BRIDGE: WEST PARAGON PARKWAY OVER LITTLE BLUE RIVER

Bridge Plans
General Plan & Elevation

3rd Party Review by HDR

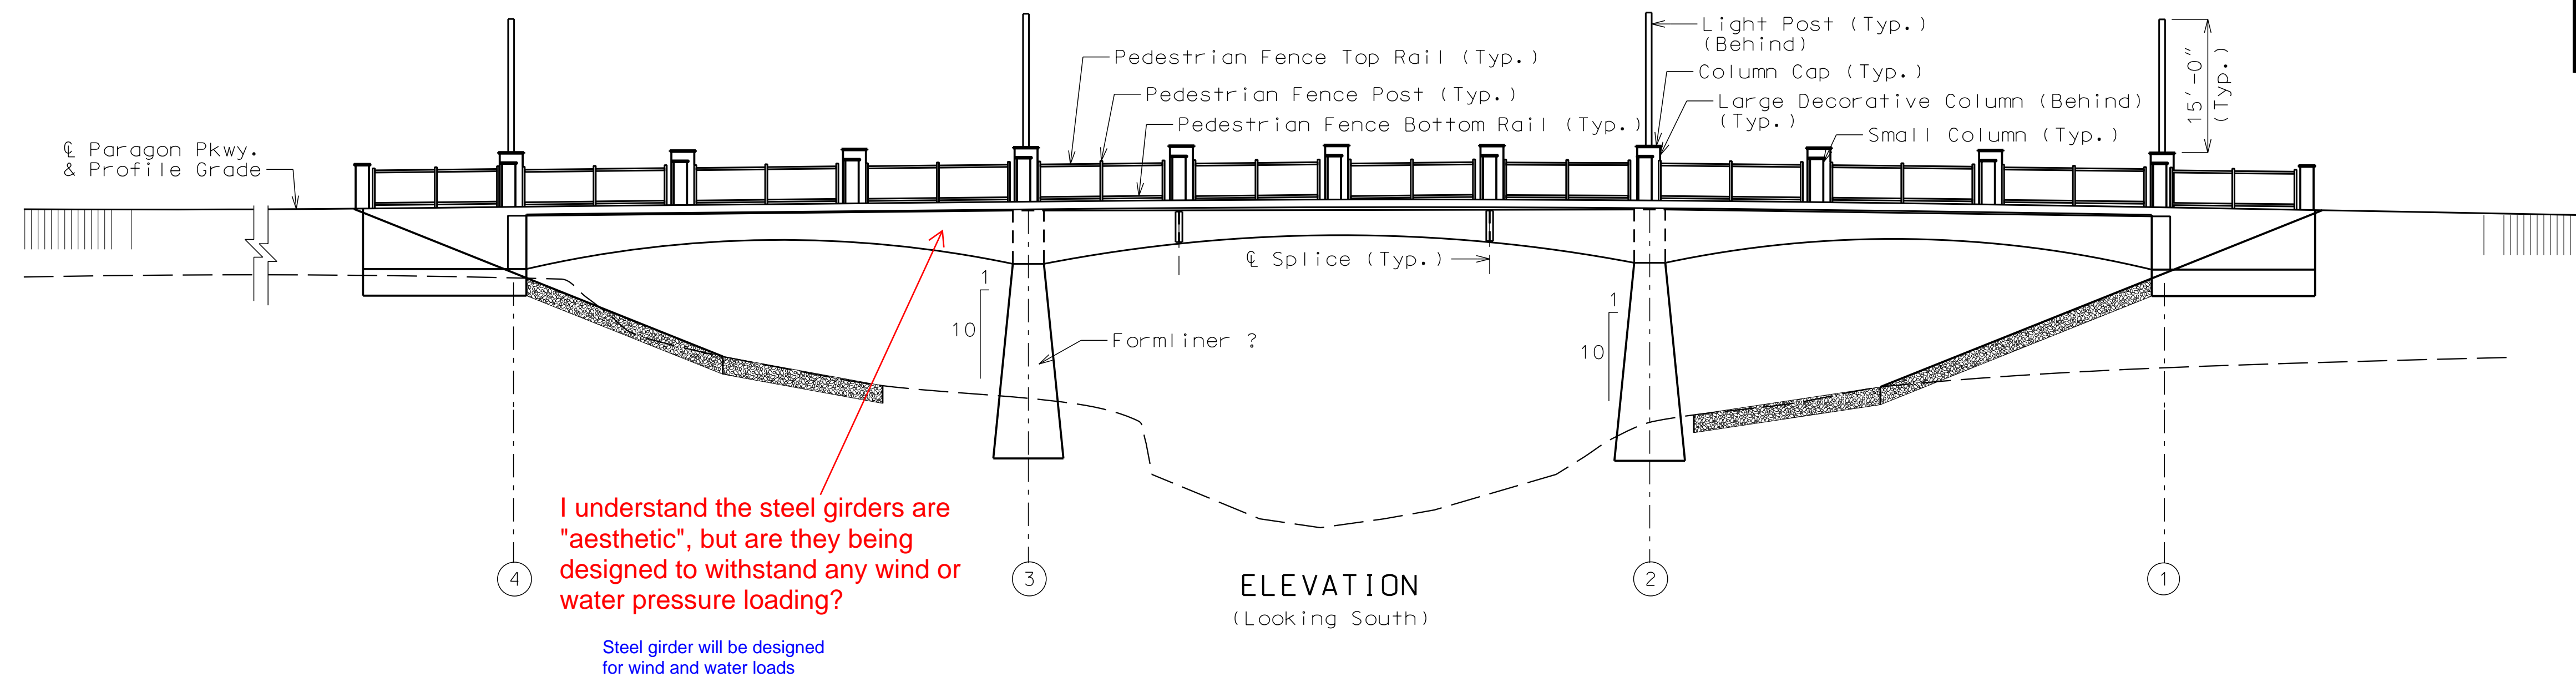
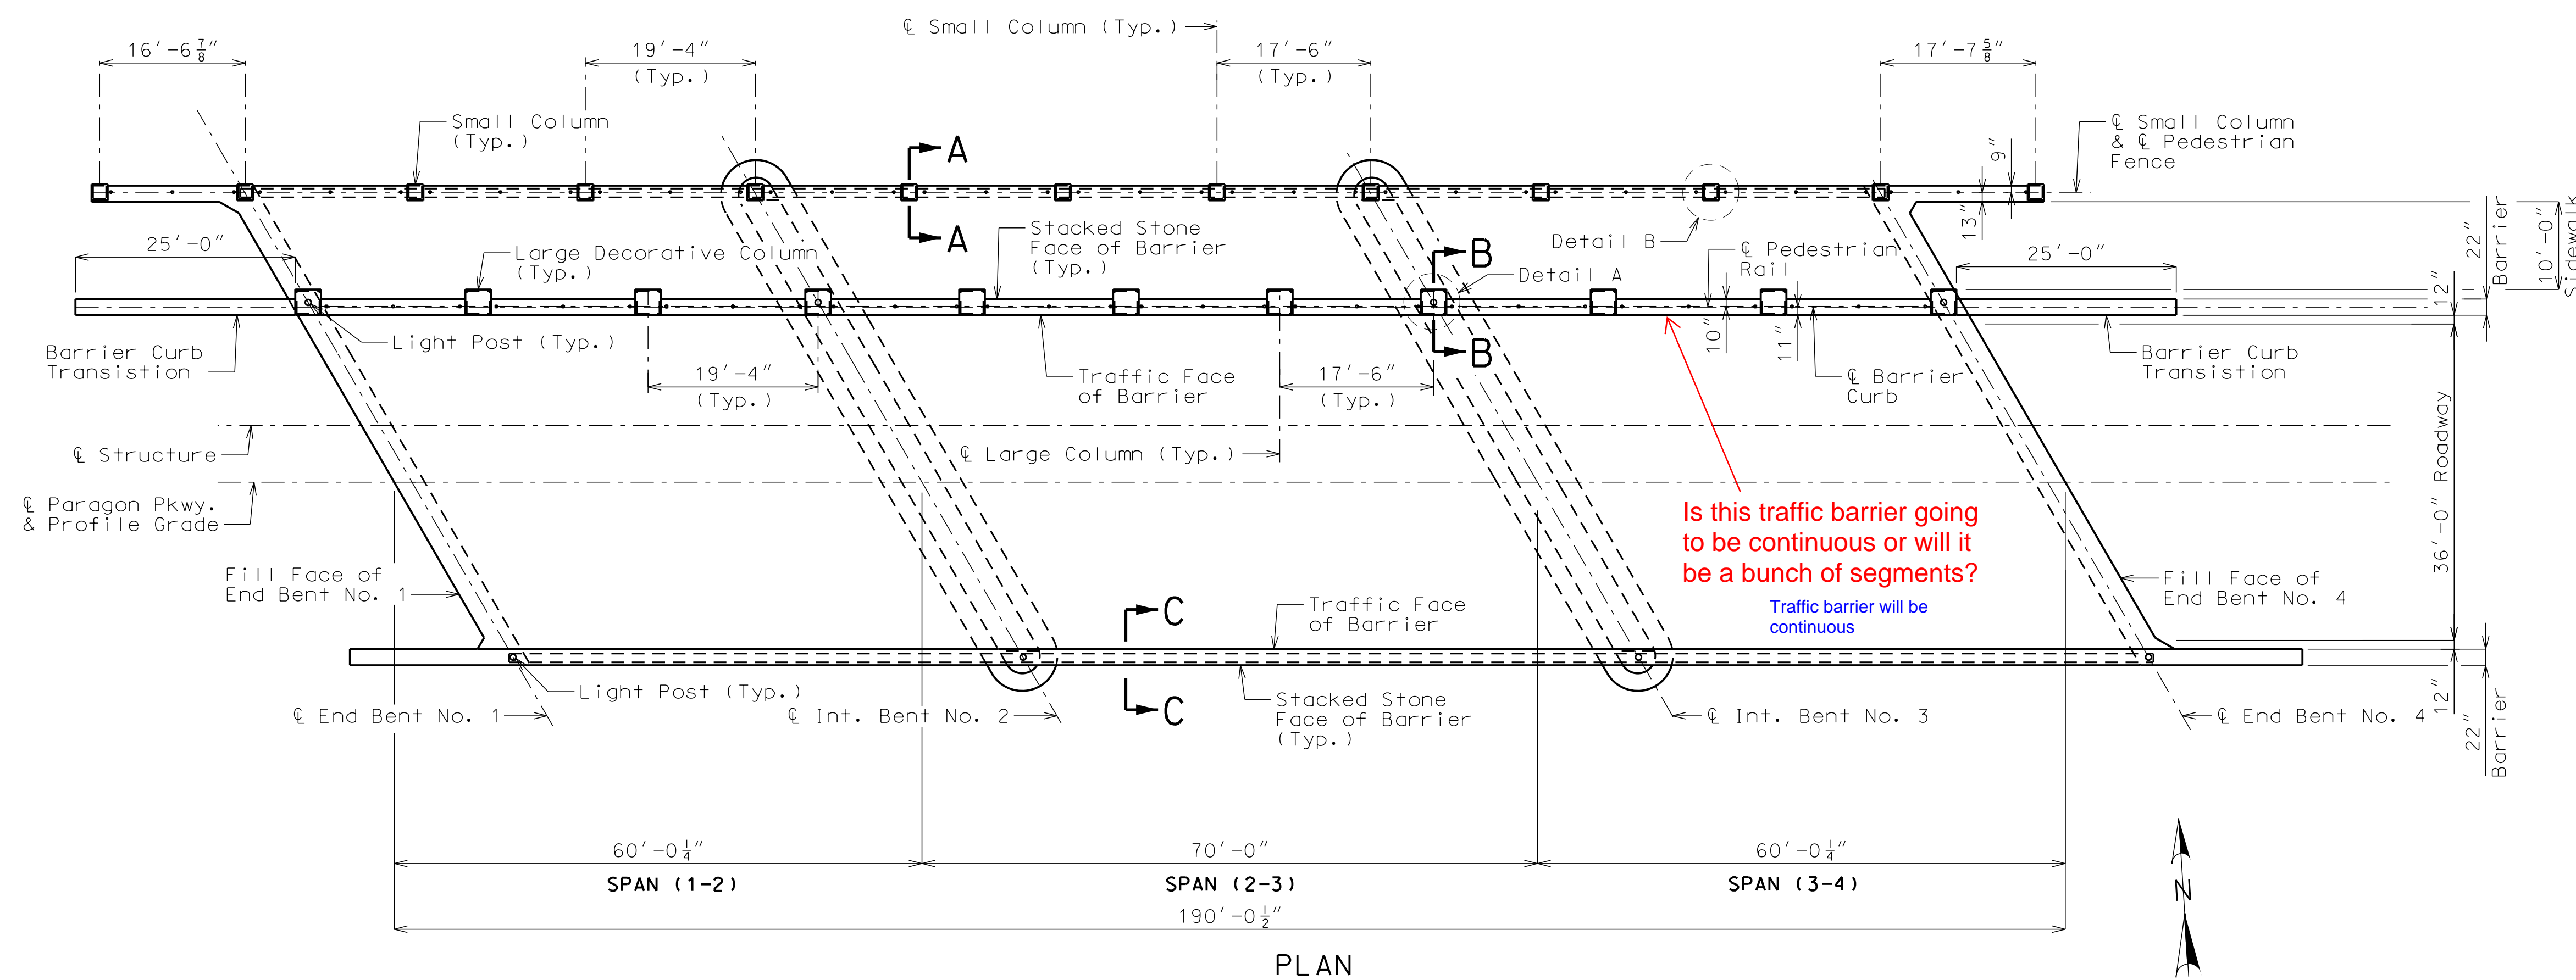
Show arrow heads pointing up station if describe grade of a tangent and use "+/-" to describe a rising or falling grade.

What does this Sta./Elev. marker signify? PVC? PVI? PVT?

Is this the VPI of a vertical curve? Provide vertical curve length

What does this Sta./Elev. marker signify? PVC? PVI? PVT?

Is this the VPI of a vertical curve? Provide vertical curve length

Remove arrow heads from grades of vertical curves. This can make it confusing with the "+/-" (typical all vertical curve callouts).

Confirm 3' End Bent cap width is adequate to provide clear between bent up strands from P/S girders and Fill Face of End Bent (typical both End Bents)

Consider expansion bearings at Int. Bents due to "stout" wall piers being proposed. Allow for expansion and contraction of superstructure (typical both Int. Bents).

What foundation type is being considered for Int. Bents? Is there concerns with scour due to depth of channel and location of bottom of wall piers shown (typical both Int. Bents).

Email from Clint Loumaster states the minimum aesthetic girder elevation is approx. 811.0 ft near abutments. This should be ok. As long as we have 2 feet of freeboard at the Int. Bents and under Span 2 for the 50-yr event then it should be ok. Keep 1 foot of freeboard for 100-yr event is a good idea though.

Were borings near Int. Bents considered? Was it going to be too difficult to get a drill rig near the Int. Bent locations?

Only showing a 12" "shy" distance between edge of lane and barrier curb? Was using a larger shoulder width considered? Can the 12" "shy" distance handle drainage without encroaching on too much of the exterior lanes?

Change made

Length of Vertical Curve added

Change made

Length of Vertical Curve added

3' End Bent cap is adequate

Expansion bearings will be considered at final design

Driven piles will be used at all locations. Scour depth will be considered. Scour is minimal.

Freeboard over the 50-yr design storm will be provided

Borings were requested. Geography did not allow for borings to be taken.

This is not a MoDOT bridge. City of Lee's Summit requires 1-lane remain open. 1-lane will be provided

Added

Added

VEHICULAR BARRIER DETAIL ELEVATION
(Vehical side shown)

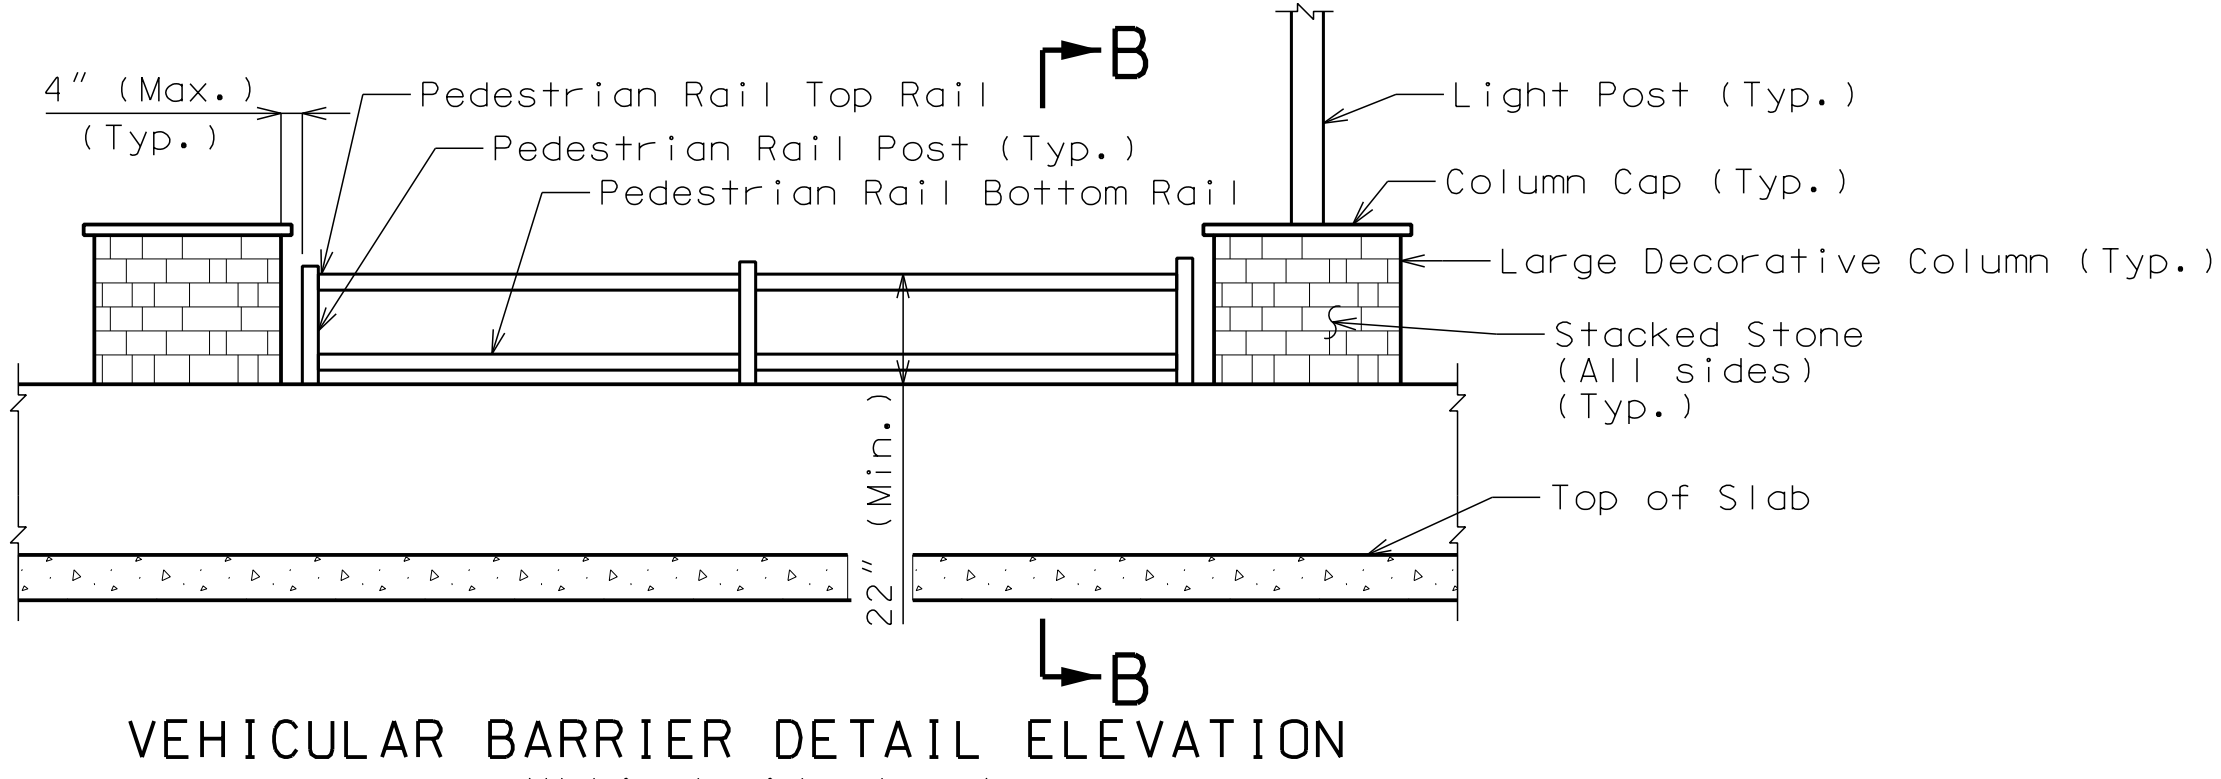
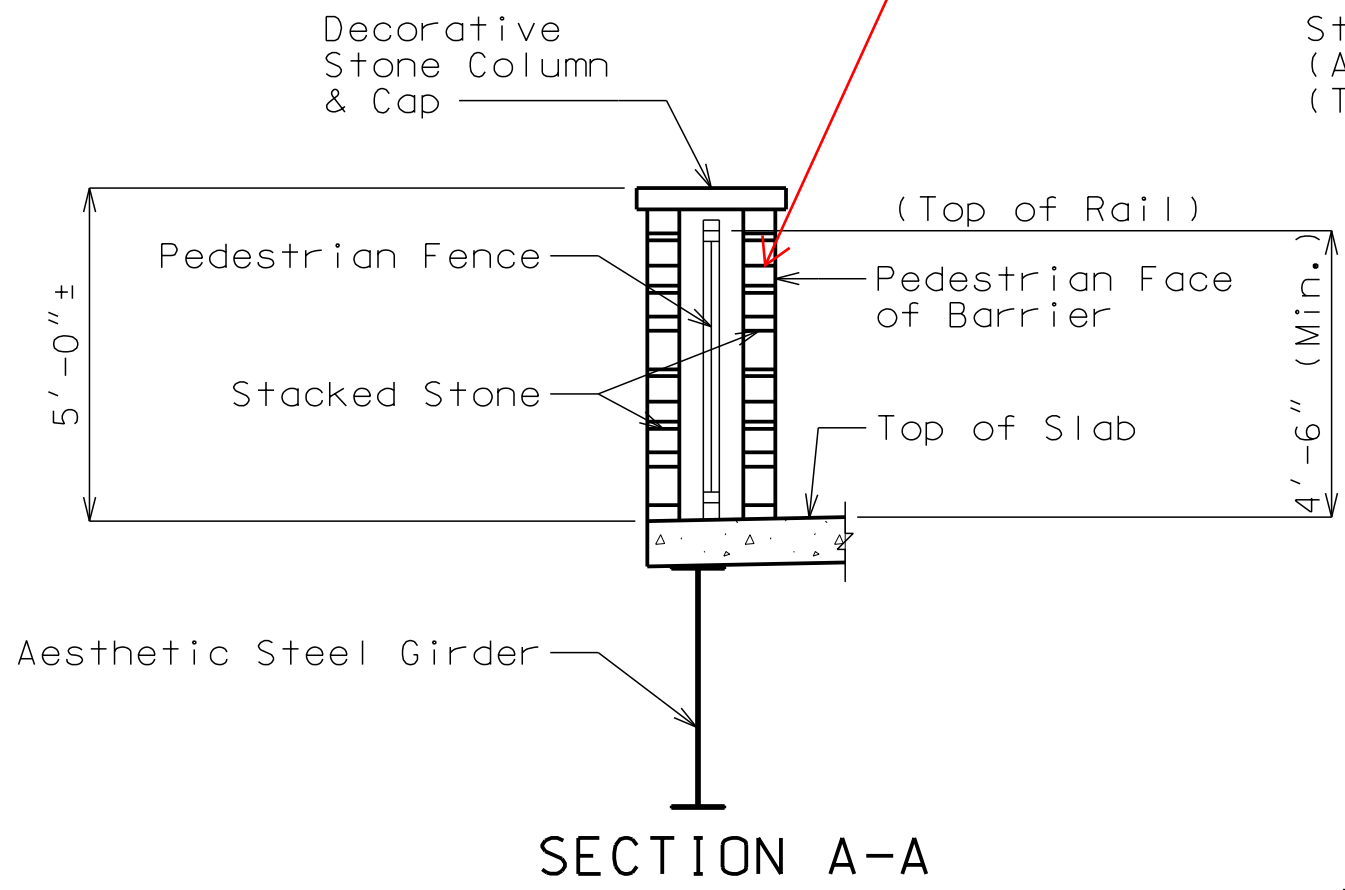
Consider details of how Stacked Stone will attach to deck and/or Columns (typical). Details will be provided at final design

Consider details of how Stacked Stone will attach to deck and/or Traffic Barriers (typical). Details will be provided at final design
